Arafura Resources NL (Arafura<sup>1</sup>) proposes to develop an open cut gold mining operation at Mt Porter, approximately 180 kilometres south-east of Darwin. The proposed operation would run for approximately eight months, scheduled to take place during the regional Dry season in 2007.

## 4 Environmental Impact Assessment

**Figure 4 - Water Management Measures and Monitoring Locations**

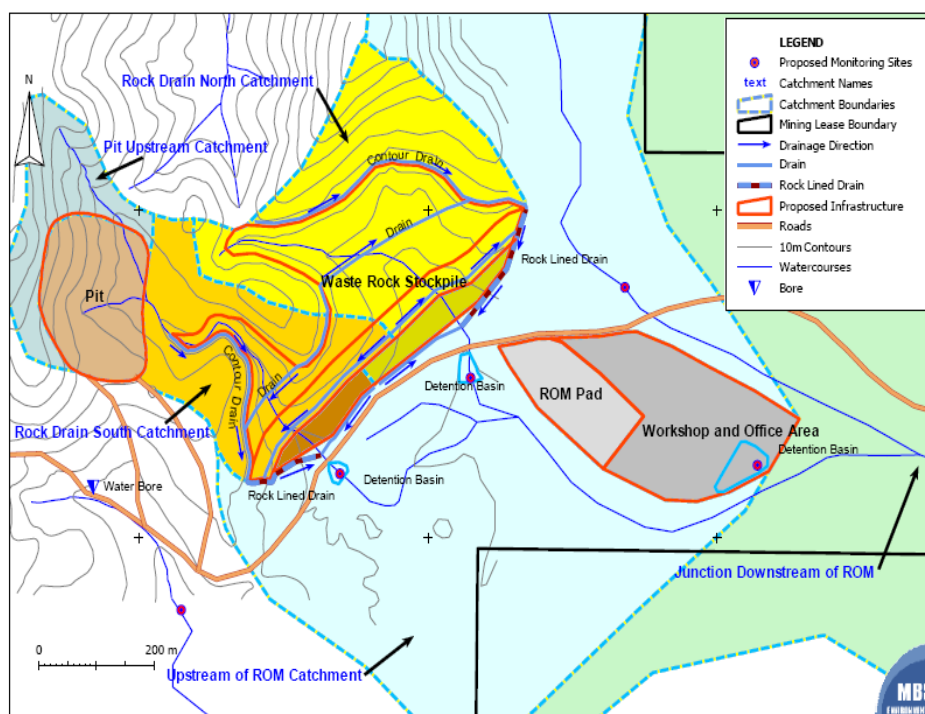
The waste rock dump is to lie across the head of the catchment of two gullies: East Gully and Pit Gully (see Figure 3, pge.15). Pit Gully contains an existing ephemeral spring in its upper reaches, above the final crest level of the waste landform. East Gully has no observed springs. Drainage from the spring and from each of the limited upper catchments (see Figure 4, pge.25) would be redirected around the upper contours of the waste landform, leading to rock armoured spillway structures on the side of the stockpile. A drainage pipe is to be buried under the WRD along each of the present creeklines to maintain a preferred drainage pathway for any groundwater infiltration into, or seepage from the WRD. PAF material is to be deposited in the southern flank of the dry East Gully and above the spur between the two valley fingers. If required, lime would be added to the PAF material to minimise potential for acid generation.

**Figure 5 -Effect of growth medium thickness on % saturation of compacted clay layer (from TeamNT2004, p.55)**

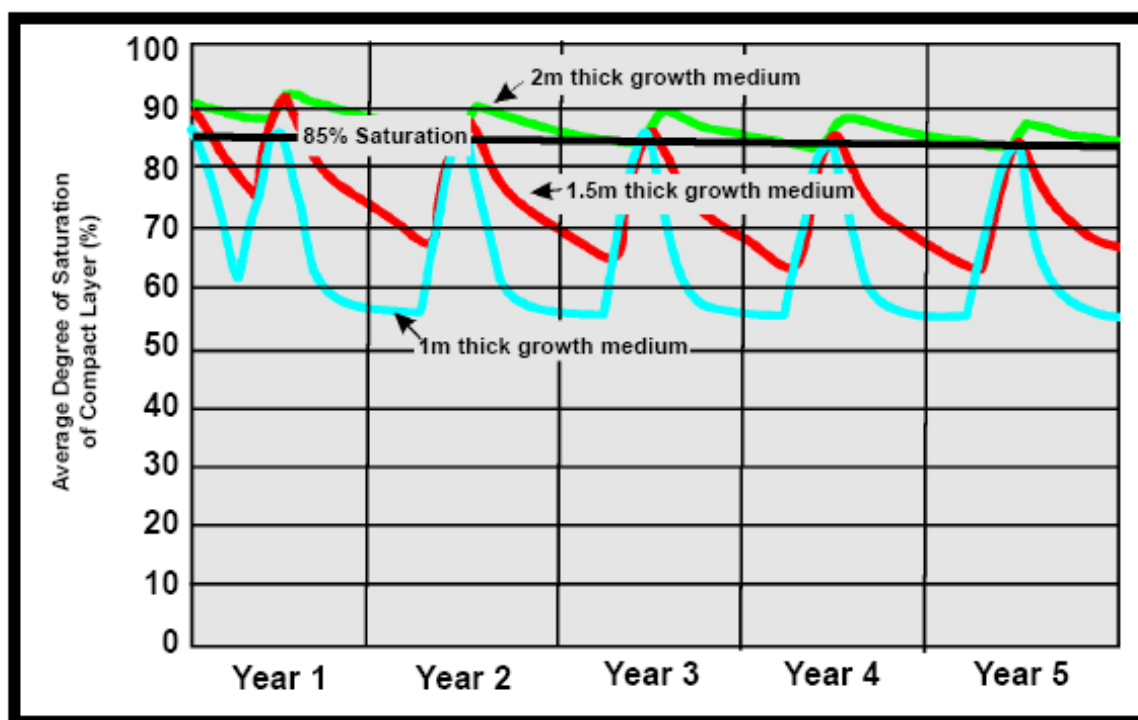
below a 85% moisture threshold (TeamNT 2004, p55). The proposed 100mm overlying layer of topsoil would not maintain such deeper moisture concentrations through much of a Northern Territory Dry season. TeamNT (2004,Ch.4)) describes currently understood best practice in design of WRD covers suitable for the NT climate. It recommends at least 2m of growth medium and topsoil be placed over the compacted clay liner, to store sufficient Wet season moisture in deeper layers to maintain the required 85% saturation of the clay liner (see **Figure 5**, pge.27).

In the cover design presented by Arafura, the clay layer is relatively exposed to weathering with only 100mm of topsoil cover. This thin topsoil layer would quickly allow underlying clay layers to undergo drying / wetting cycles with associated contraction / expansion and development of increasing lines of weakness. This has the potential to lead to cracking and development of preferential flow pathways, leading to high permeability into the underlying waste during the wet cycle. Seepage and oxidation would then increase, resulting in leachate drainage from the base of the dump throughout the year.

In the cover design presented by Arafura, the clay layer is relatively exposed to weathering with only 100mm of topsoil cover. This thin topsoil layer would quickly allow underlying clay layers to undergo drying/wetting cycles with associated contraction / expansion and development of increasing lines of weakness. This has the potential to lead to cracking and development of preferential flow pathways, leading to high permeability into the underlying

waste during the wet cycle. Seepage and oxidation would then increase, resulting in leachate drainage from the base of the dump throughout the year.
